19 May 2017

GILGANDRA SOLAR FARM (SSD 6785) - EIS EXHIBITION

Gilgandra Shire Council

Drawing R6

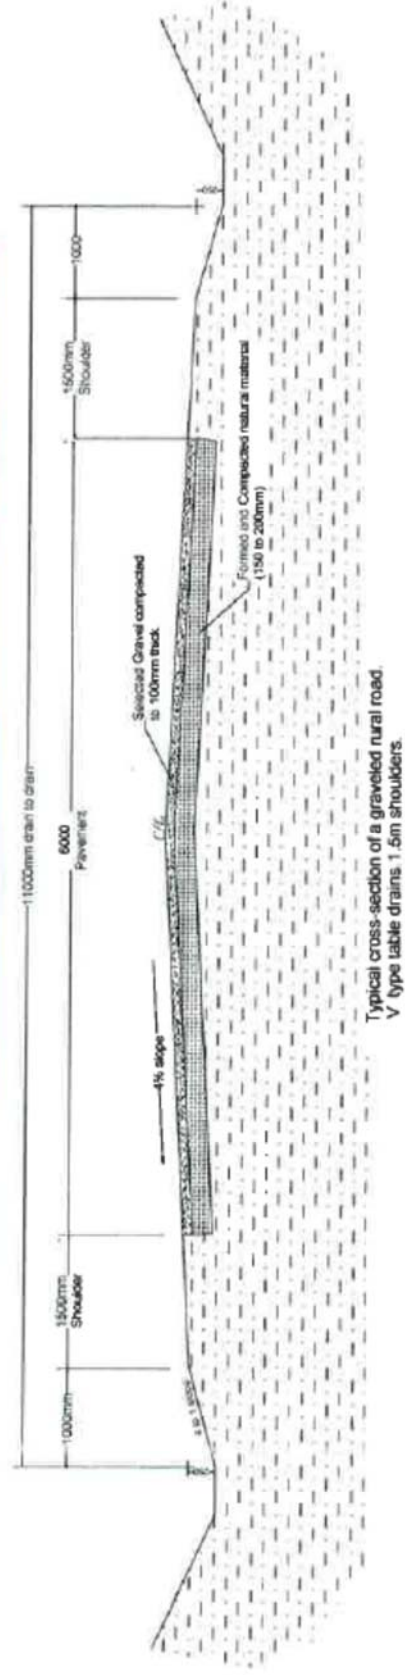
- d. Acknowledge that Council's local road hierarchy plan lists Baroona Road as a "secondary through road" (ST) so the road is to satisfy the objectives and standards required of a secondary through road
Reason - Full provision for traffic harmony and road safety

- e. Ensure that all Baroona Road wearing surfaces and the site ingress/egresses from the edge of the Baroona Roads to the gateway are finished with a recognised stable road base (gravel)
Reason - Full provision for traffic harmony and road safety

Attached is a copy of a drawing detailing the minimal requirements of the Shire's Rural Local Secondary Through Road (ST).
